Addendum #3

Date	10/13/2026	**Bid Date& Time**	Thurs., Oct. 15, 2026 @ 2:00 PM
Project	Broadlawns Brain and Memory Center		
Project No.	14138B		
Attachments	**2 Specification Sections (9 pages):** Section 00 41 00 **4 Architectural Drawings:** A-121, A-302, A-401, A-701 **3 Civil Drawings:** C1.2, C4.1, C6.1		
Distribution	Bidders List

BROADLAWNS BRAIN & MEMORY CENTER

Sheet No.
A-121

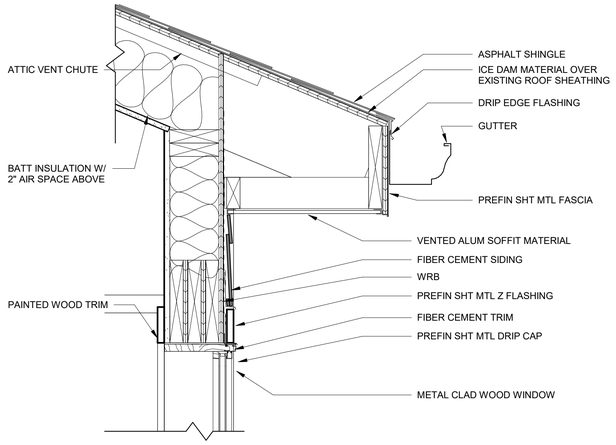
4. Sheet A-121 REFLECTED CEILING PLAN -
    a. **ADD** line to indicate a cubicle curtain on the west side of the dividing wall in Lab 128.
    b. **ADD** note to that line that says: CUBICLE CURTAIN & TRACK.

Sheet No.
A-401

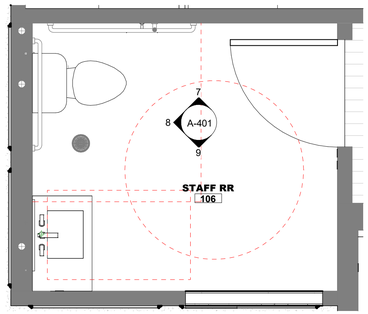
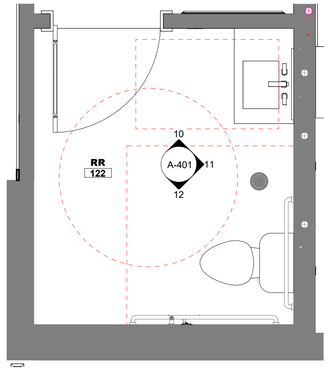
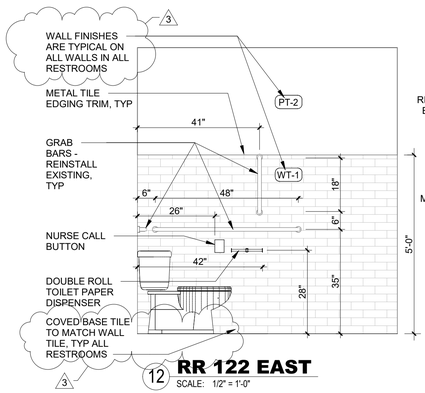
6. Sheet A-401 BATHROOM PLANS & ADA CLEARANCES – RESTROOM FIXTURE & EQUIP. NOTES
    a. Under #2 **DELETE** the SANITARY NAPKIN DISPOSAL PER RESTROOM.
    b. Under #2 **ADD** to the COAT HOOK note: HEWI 805.90.011 STAINLESS STEEL SINGLE WALL HOOK.
    c. Under #3 **ADD** to the COAT HOOK note: HEWI 805.90.011 STAINLESS STEEL SINGLE WALL HOOK.
    d. Under #3 **DELETE** 1 LIQUID SOAP DISPENSER PER SINK
    e. Under #4 **DELETE** 1 LIQUID SOAP DISPENSER PER SINK
    f. Under #6 **DELETE** at the end of the sentence “& MIRRORS.”

Sheet No.
A-701

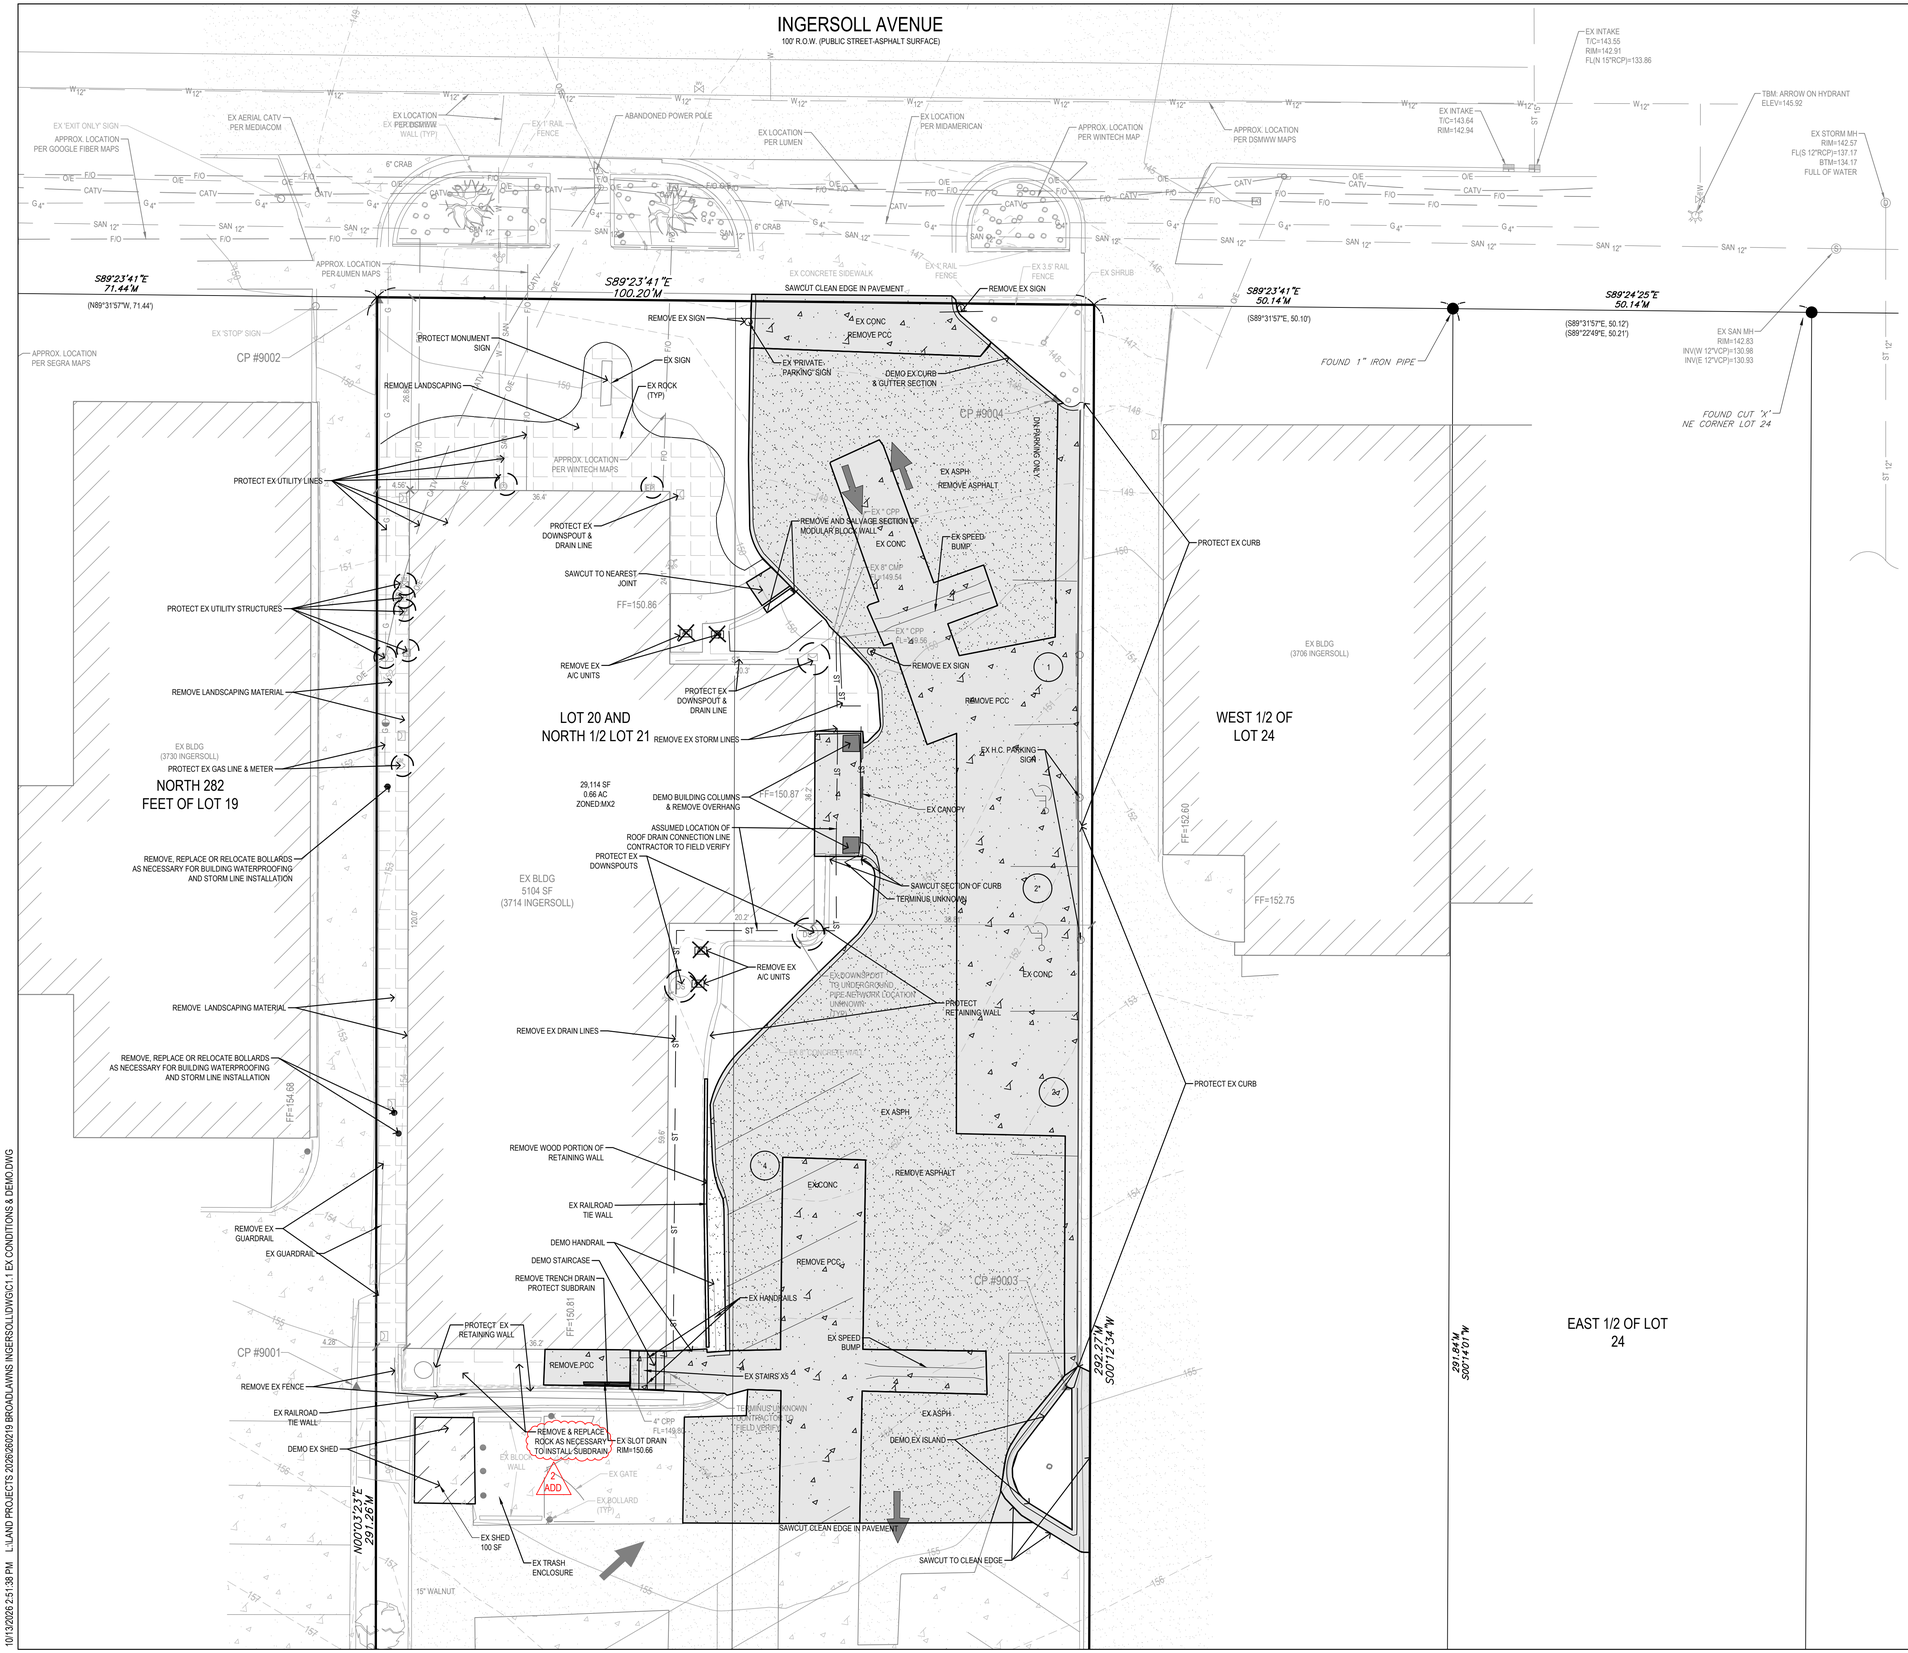
7. Sheet A-701 INTERIOR FINISHES, INTERIOR FINISHES KEY
    a. **REVISE** after the symbol WS: WINDOW ROLLER SHADE: PHIFER 2500 OYSTER/PEARL GREY 1% OPENNESS

SHEET NUMBER: C1.2

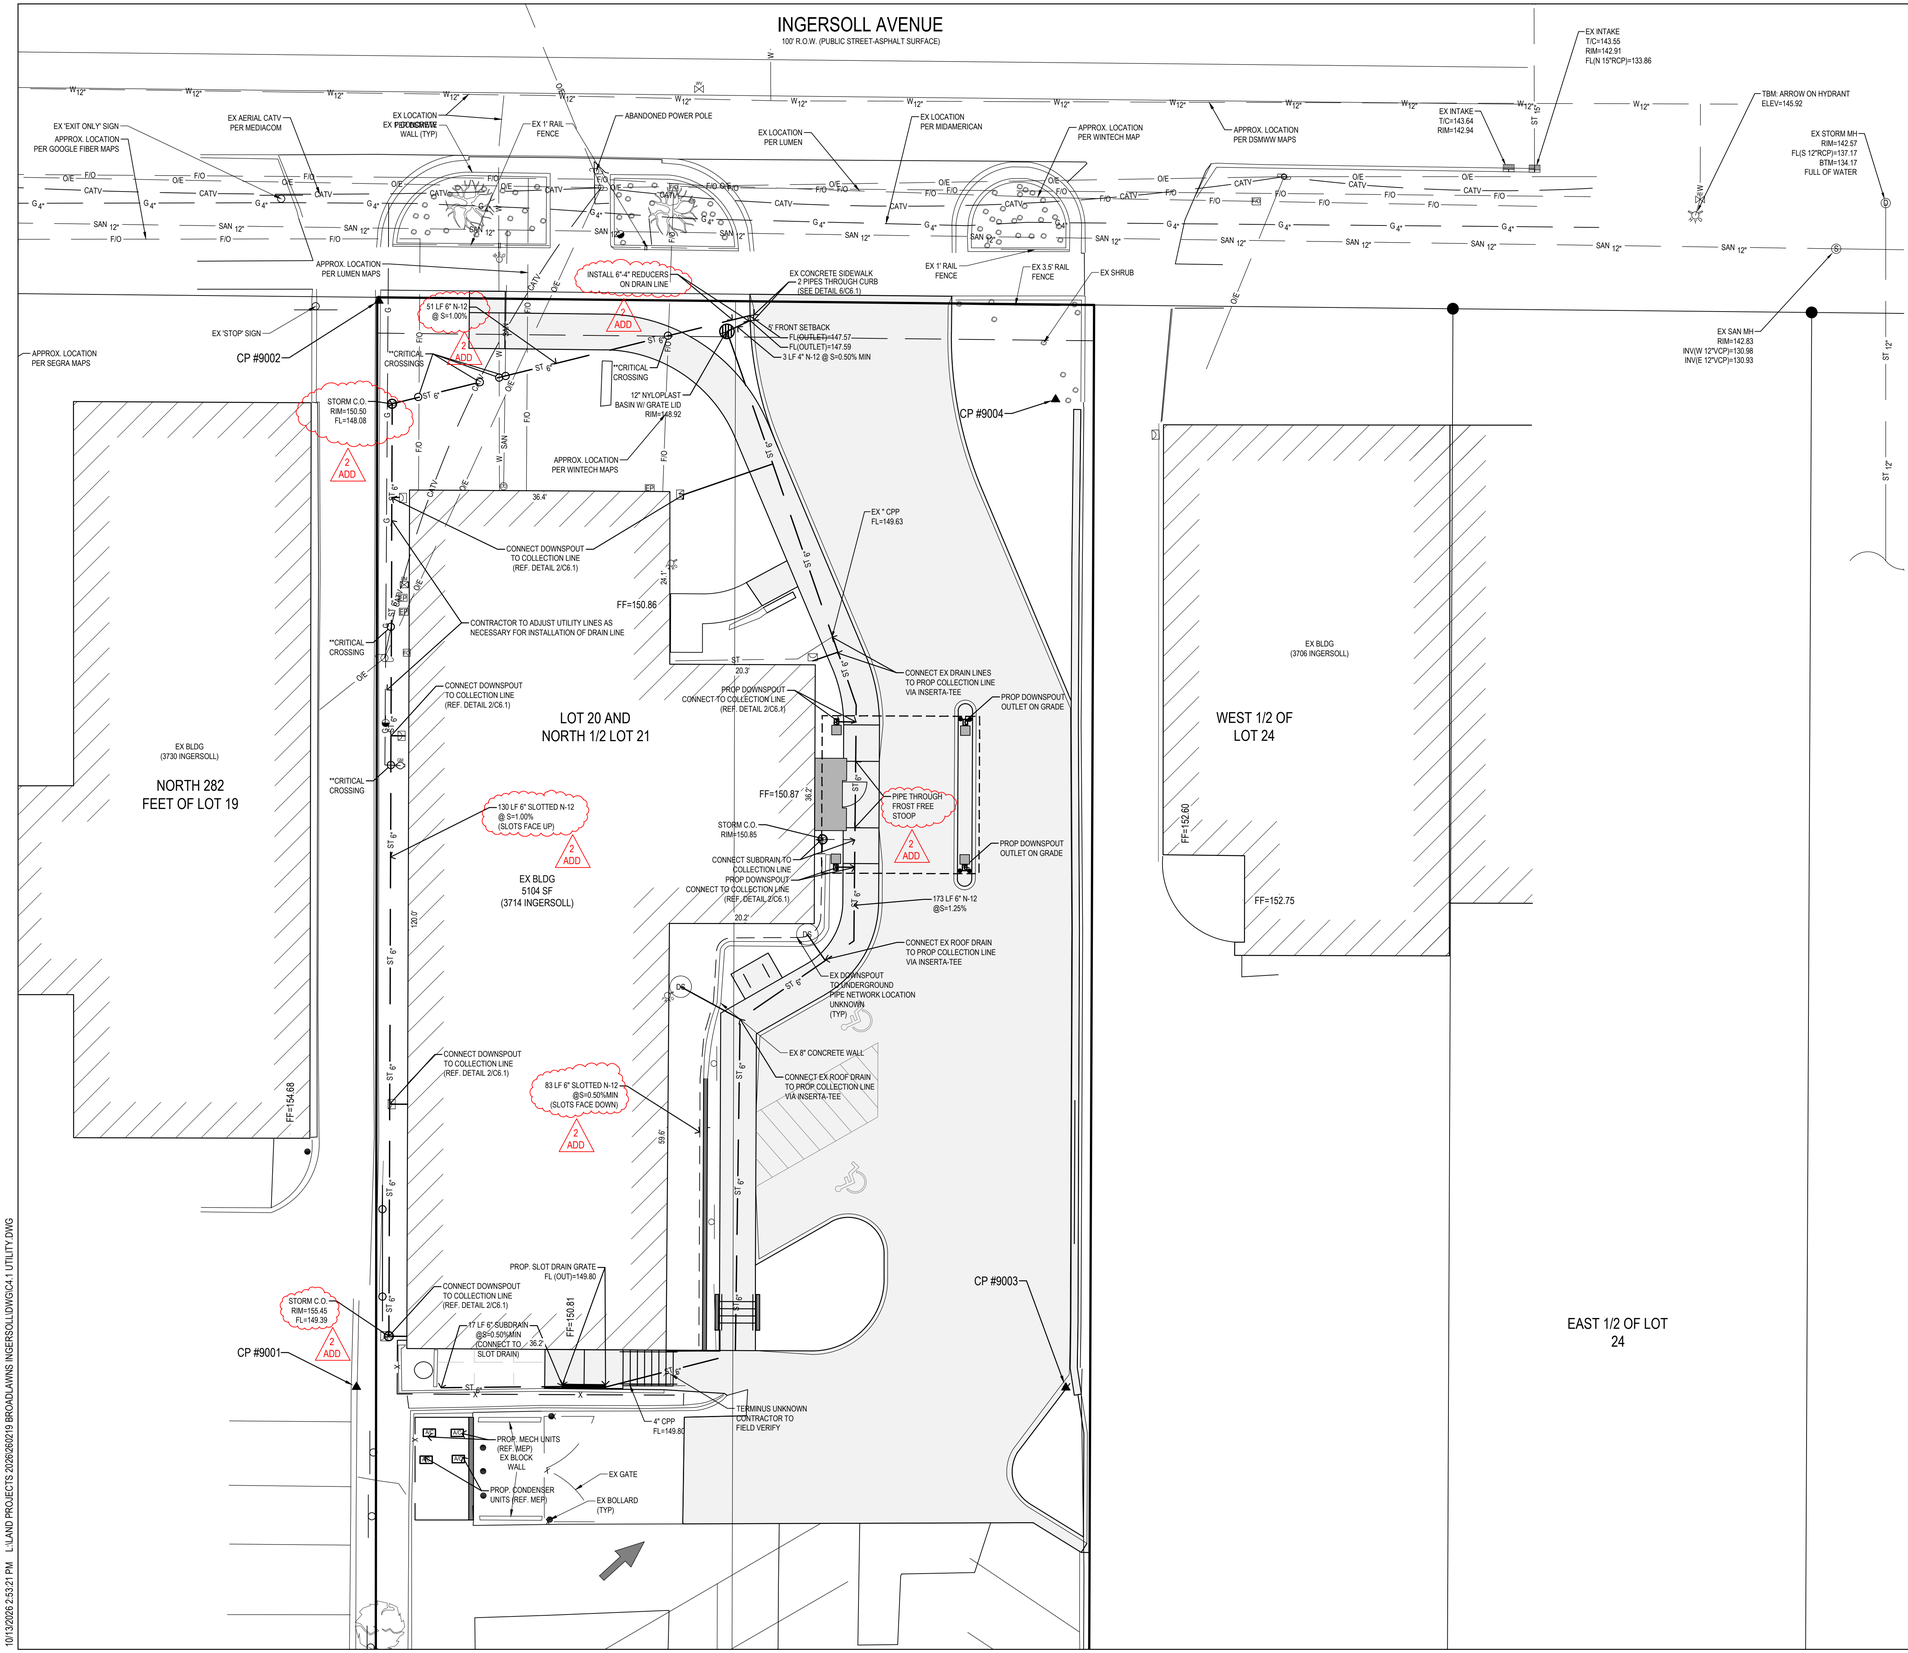
8. C1.2 Ex Conditions & Demo:
    a. **ADD**: Callout to remove & replace as necessary for subdrain installation
